ADDENDUM NUMBER ONE

**Liberty First Credit Union
North 84th Street & Lexington Avenue
Lincoln, Nebraska
Project #: 2011-20**

DATE OF ISSUE: October 1, 2011

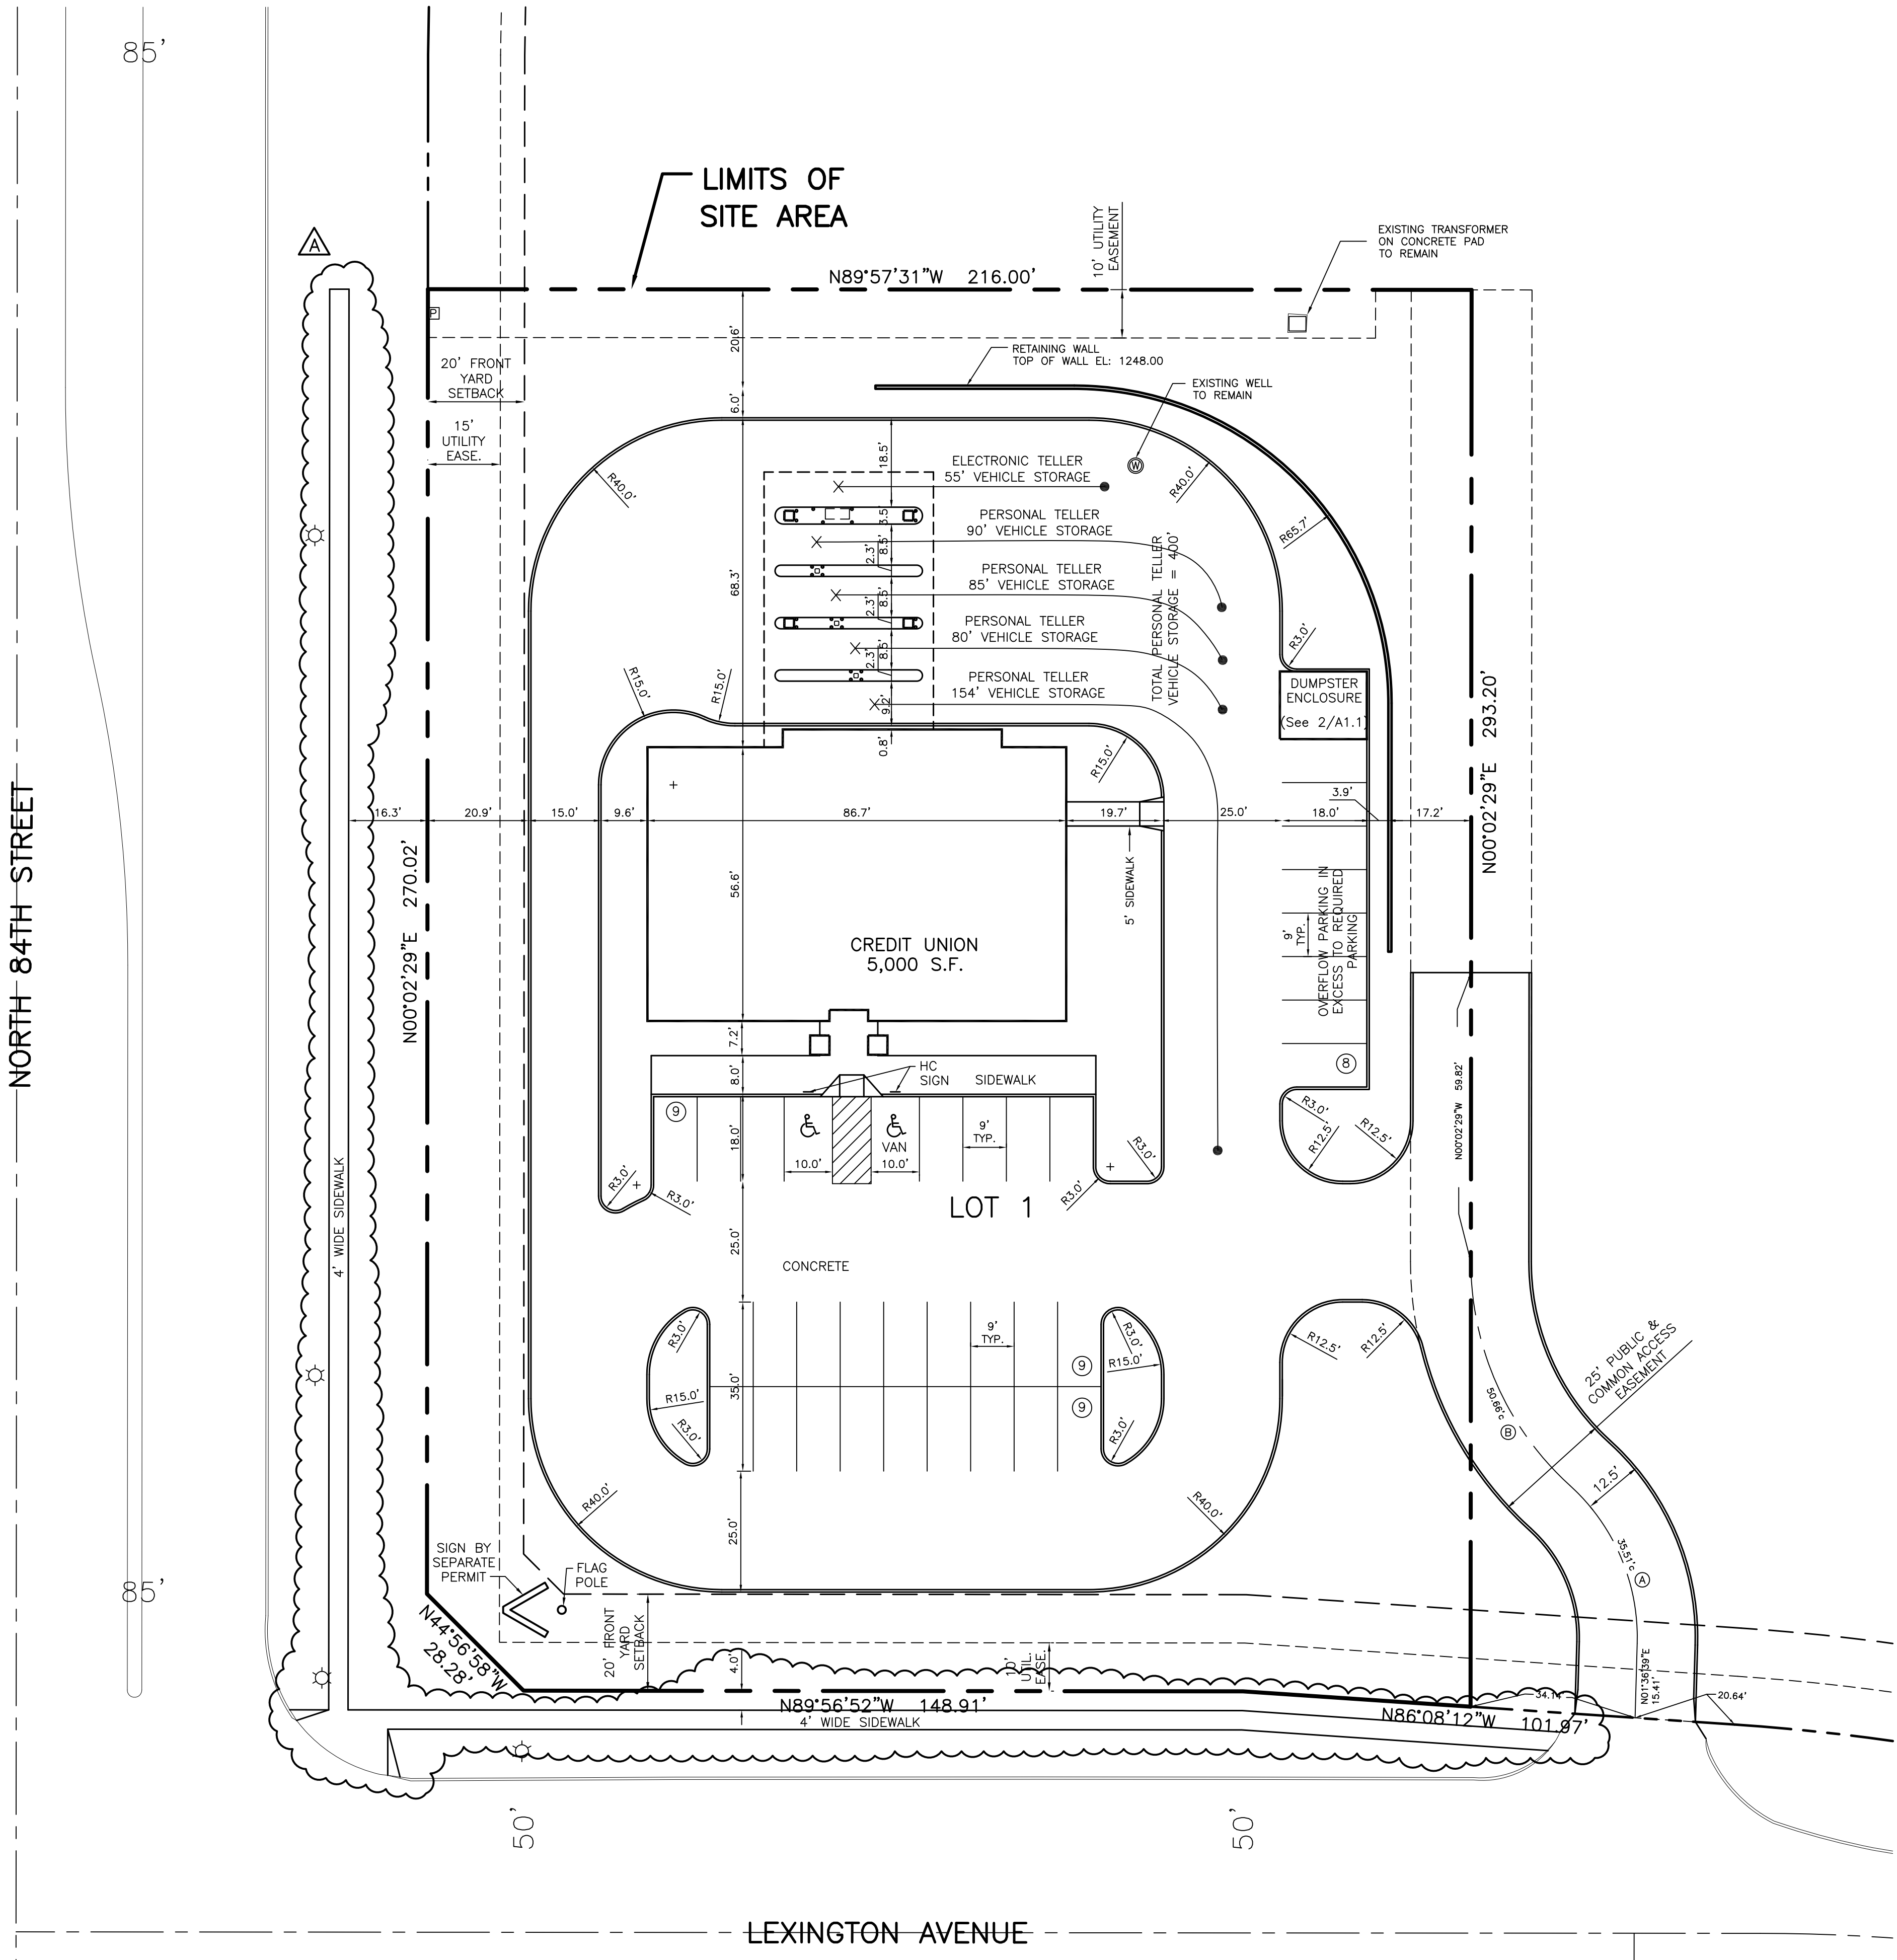
1. Revisions to walk along N 84th Street and Lexington Avenue.
See attached revised sheet C1.0

Sheet C2.0 – Grading Plan

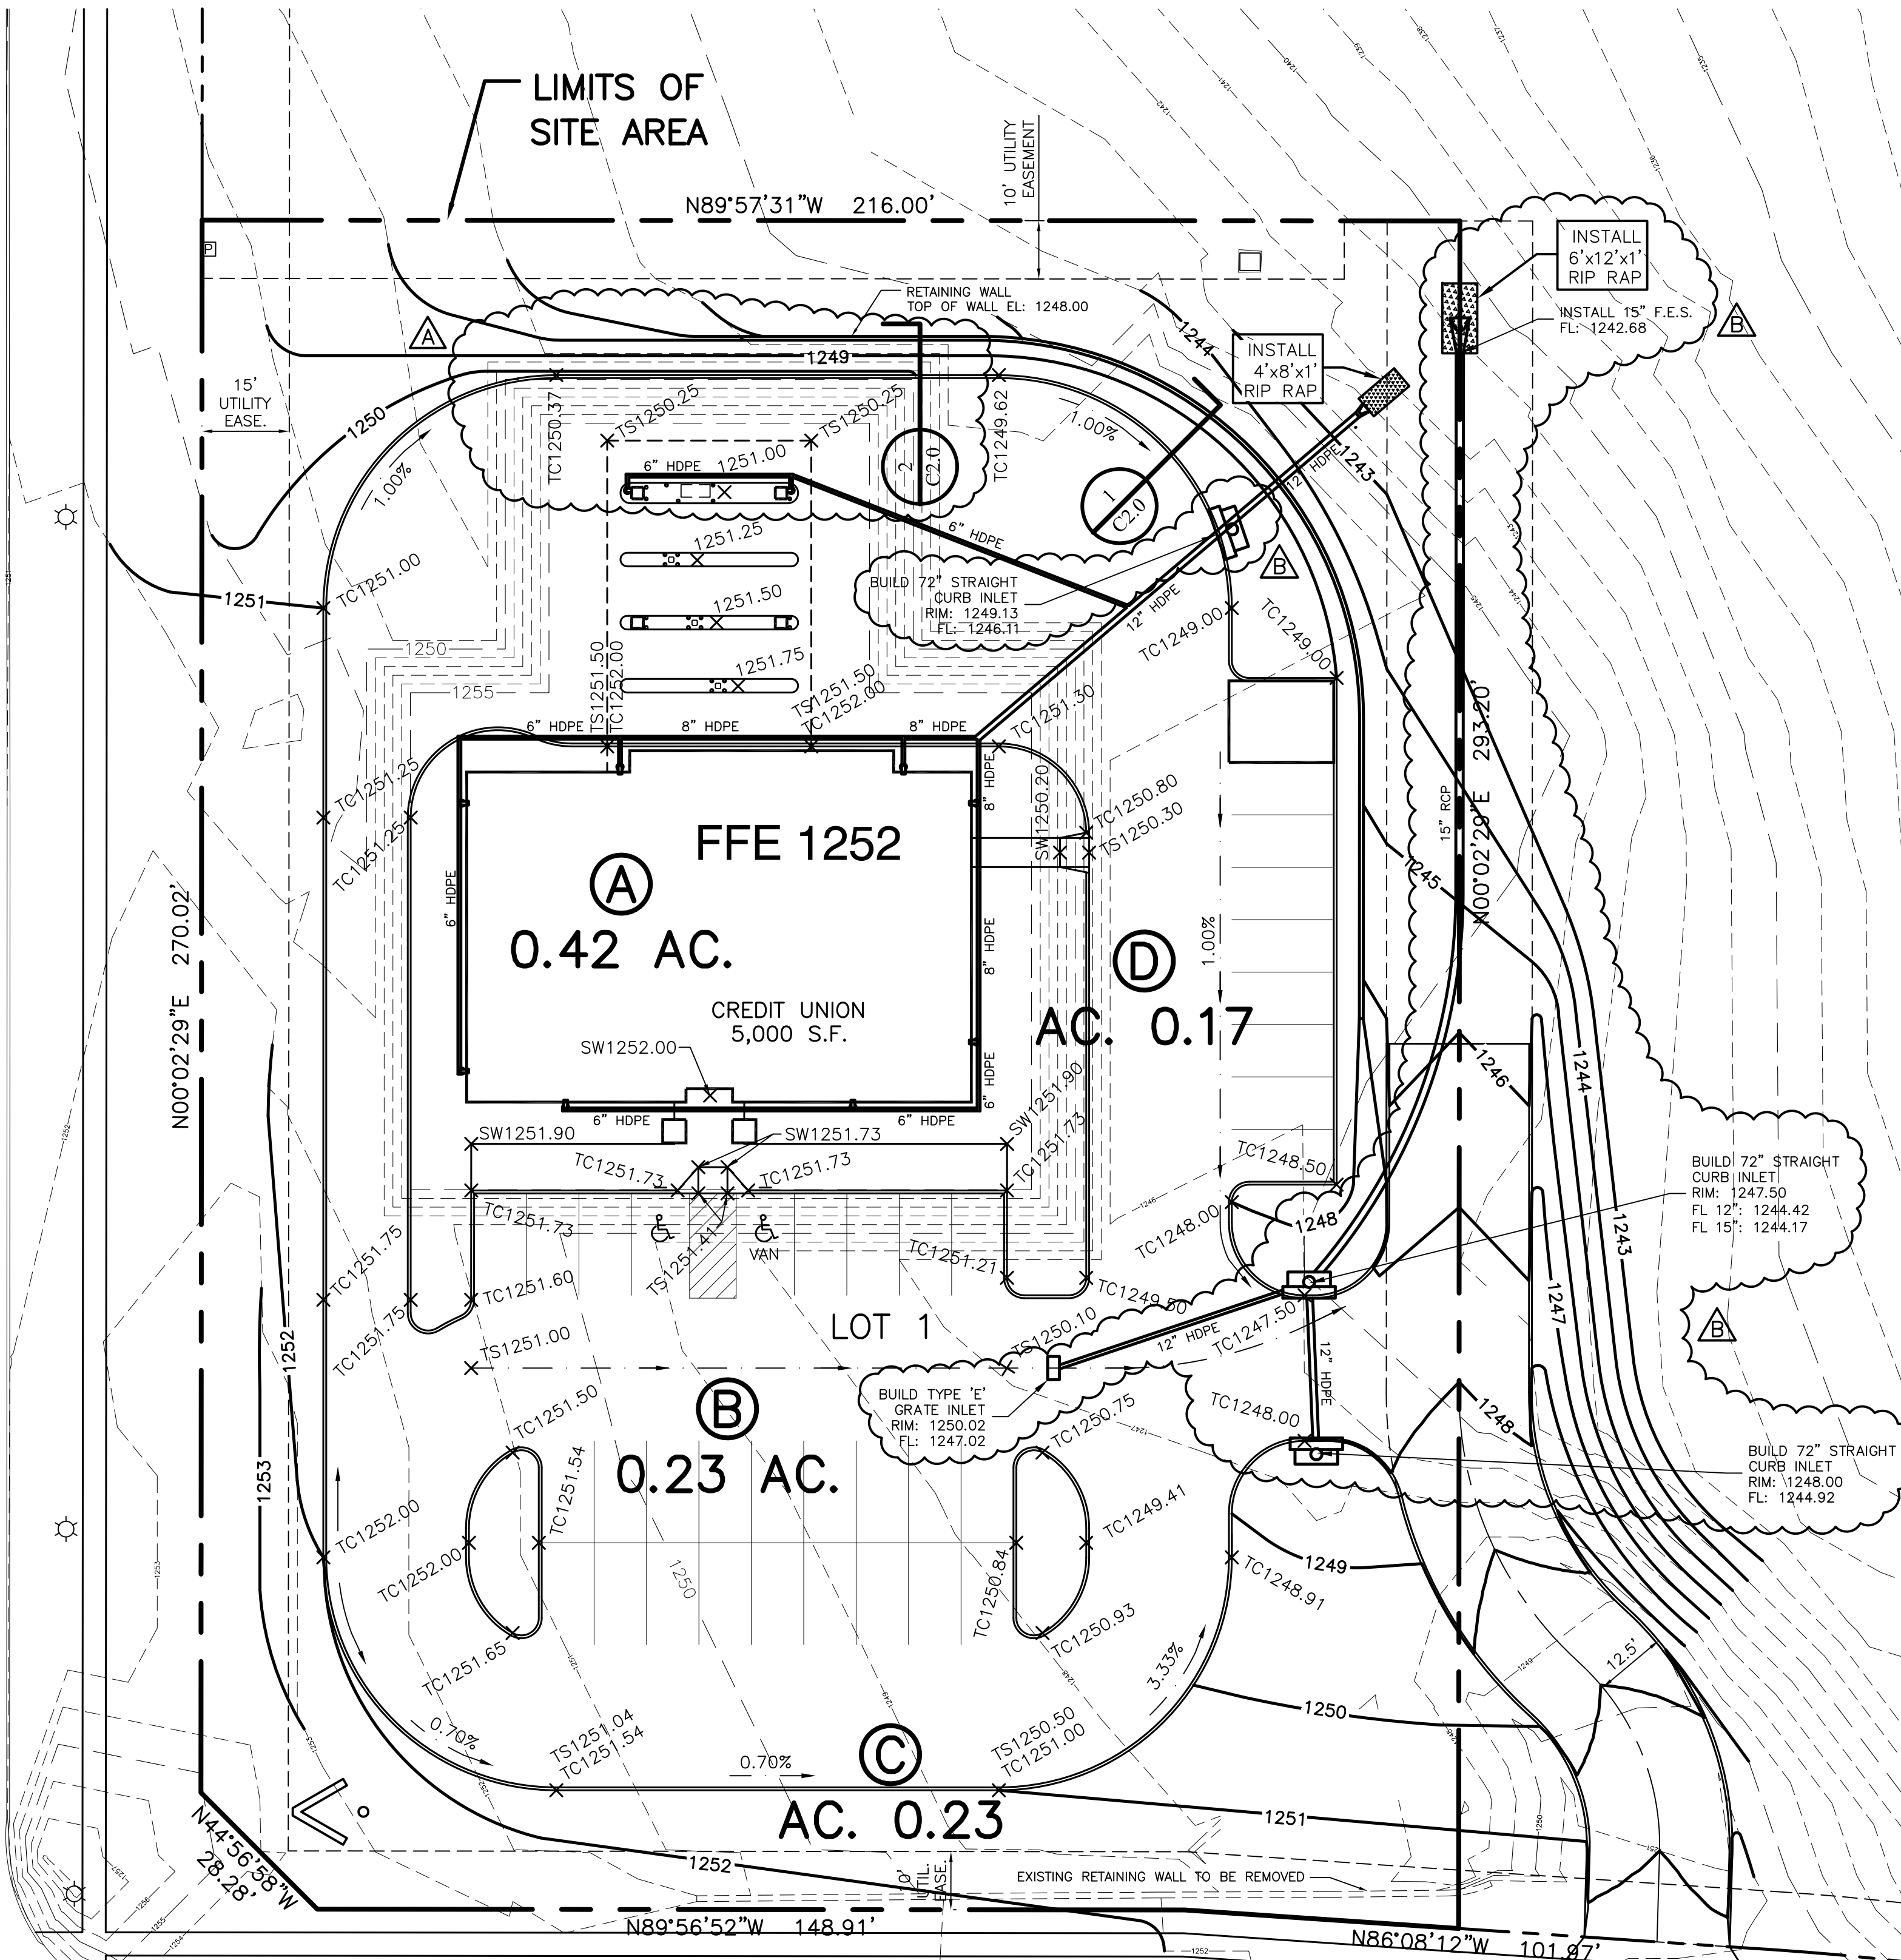
2. Addition of storm water inlets for parking lot and drive drainage to be included in Alternate No. 2.
3. Adjustment of extent of surcharge grading shown. Surcharge north of the drive-thru canopy does not extend as far as previously shown.
See attached revised sheet C2.0
